SERVICE MEMORANDUM

OIL SEALS -- GEARBOX REAR EXTENSION

MGA

MAGNETTE

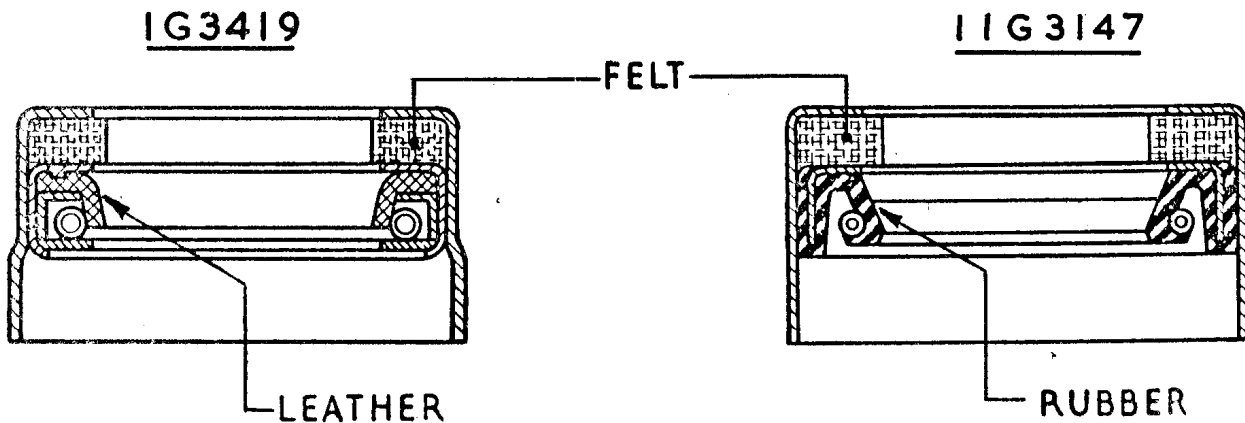
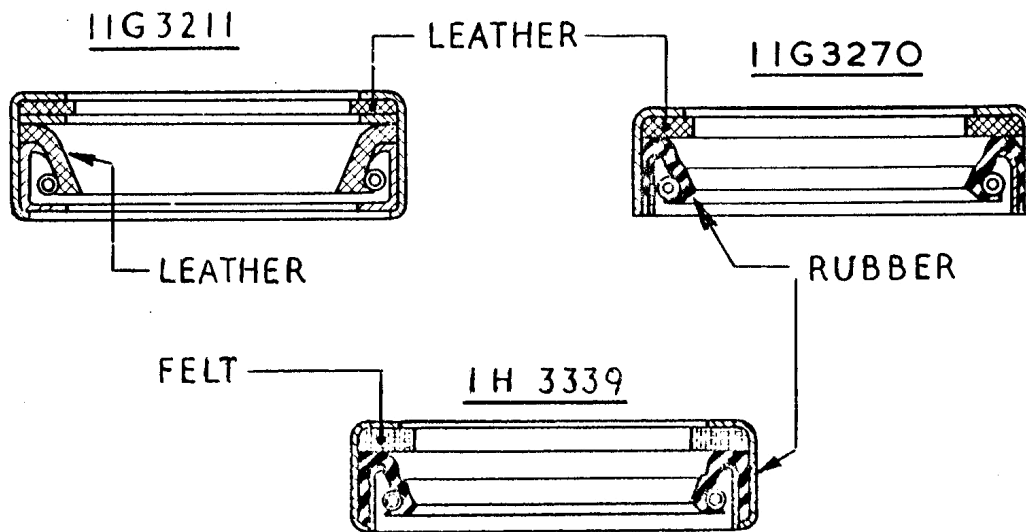
Five types of seal have been fitted as standard.

The tables below and overleaf indicate the engine number range for each type, also the correct seals to be used as service replacements:

N.B. The above does NOT affect the MGA Twin-Cam model to which only oil seal Part No. 1H3275 has been fitted.
